## **ZONING CHANGE REVIEW SHEET**

**CASE:** C814-2017-0001 – 425 W. Riverside PUD

**ADDRESS:** 425 W. Riverside Drive

**ZONING FROM:** CS-1-V-NP      **TO:** PUD-NP

EXAMPLE TREEWELL  
SECTION VIEW SCALE: 1/2"=1'-0" 02

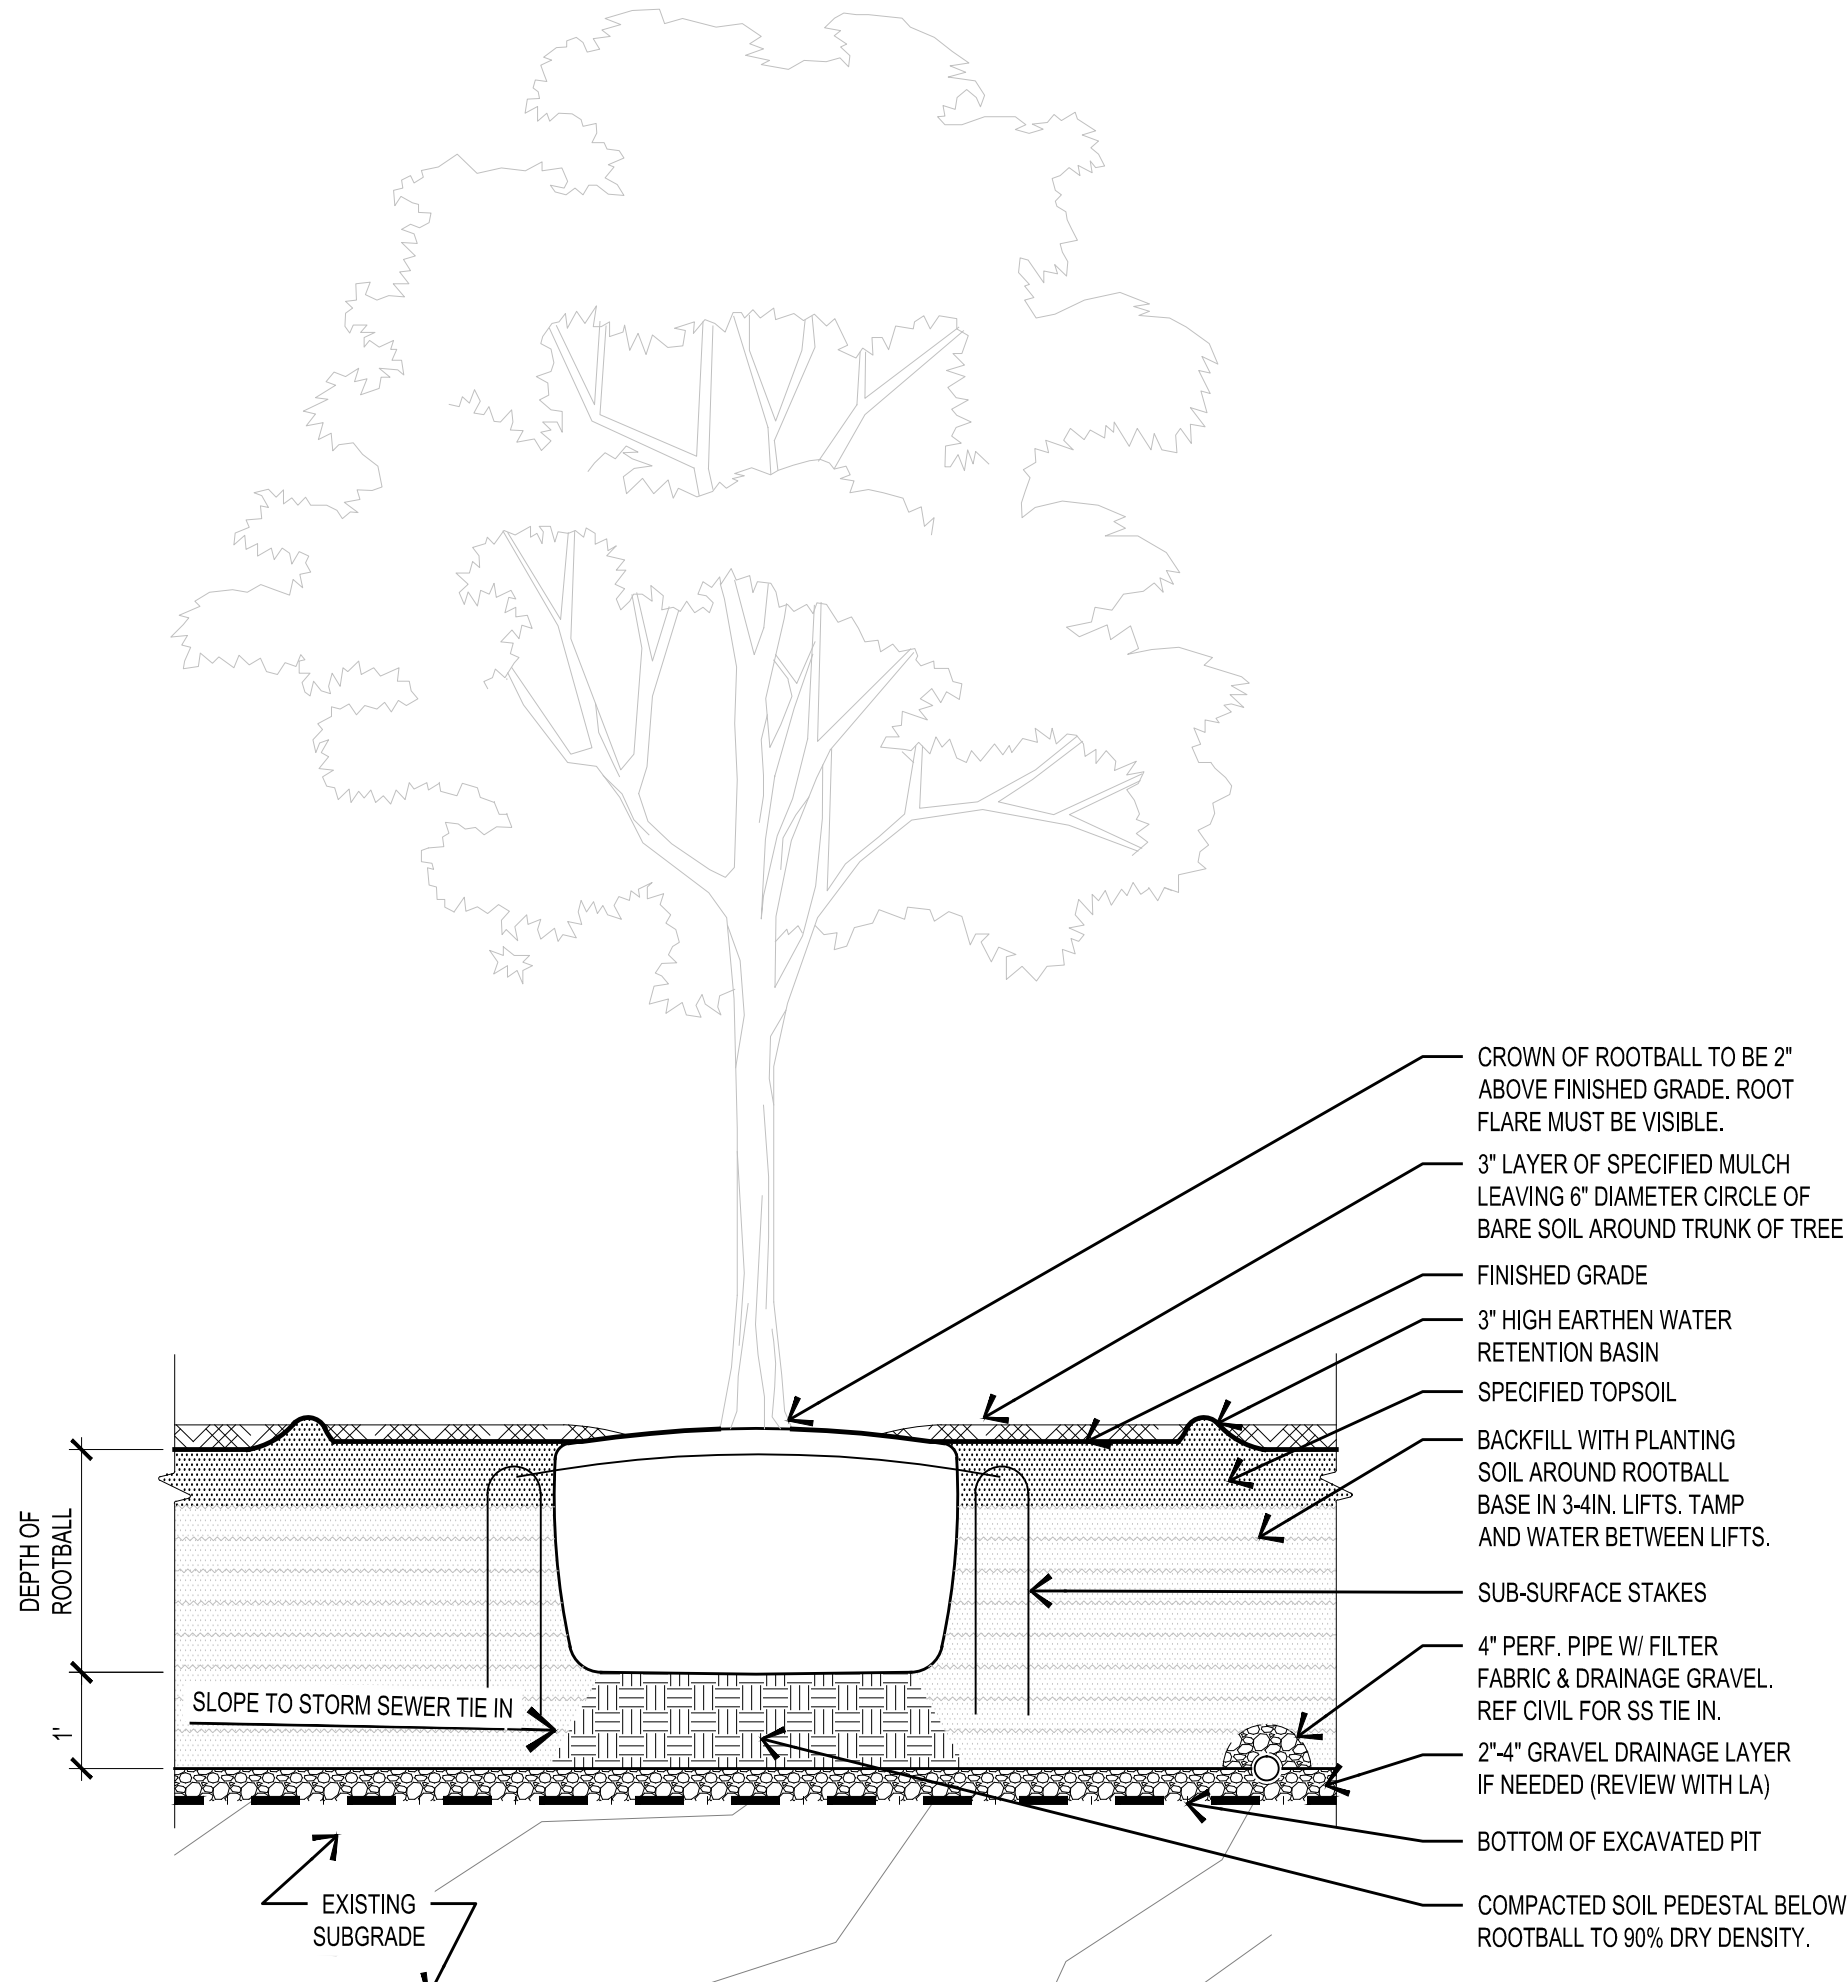
**UPDATE 1:** Please show how at the proposed spacing between street trees the PUD can achieve 1,500 Cu.Ft per tree. See HT 1 response. The proposed rain garden areas would not seem to be able to meet this area requirement if they were walled confined spaces. Please clarify if the planting zone is truly 8 feet or if it will really be 7.5 feet or less to account for the curb or any type of moisture barrier between the zone and back of curb. Comment pending.

**UPDATE 2:** Staff is still unclear how the overall inches to be planted number was derived as I only received one of the two exhibits mentioned in your response. Please provide at our next meeting for review. Soil volume will also be discussed and the commitments and exhibits needed for the final PUD document. Comment pending.

**UPDATE 3:** Thank you for the additional information and calculations. While the PUD proposed planting of a larger diameter street tree could be considered for some environmental superiority, it would normally be a proposal to plant more trees than what would be required that would carry more weight. The PUD proposes a starting overall total frontage a bit less than the current code scenario. It also proposes an additional loss of frontage to accommodate greater options for alternative transportation with two new bus stops. These additional losses in total only allow the PUD scenario to plant one additional tree than the current code option. In this case, it will be the guarantee to plant a shade tree of higher quality that will carry some environmental superiority. To this point, because a multiplier has been used in both calculations to estimate loss due to utility conflicts and not on the ground verification staff is still not able to support the overall tree planting estimates.

**Please also revise your soil commitments and notes to be consistent with the last update. These should include the larger 1540 CY soil volume required in locations other than ones with utility conflicts. In those cases where it is proven utility conflict then 1000 CY minimum is accepted with the use of soil cells. Comment pending.**

**UPDATE 3: Using the ANSI planting standards is acceptable but not superior, as these would be done anyway. Please explore additional standards for tree quality, to assure the best possible tree stock is available for the PUD. These could include presence of visible root flare a time of planting and no girdling roots. Comment pending.**
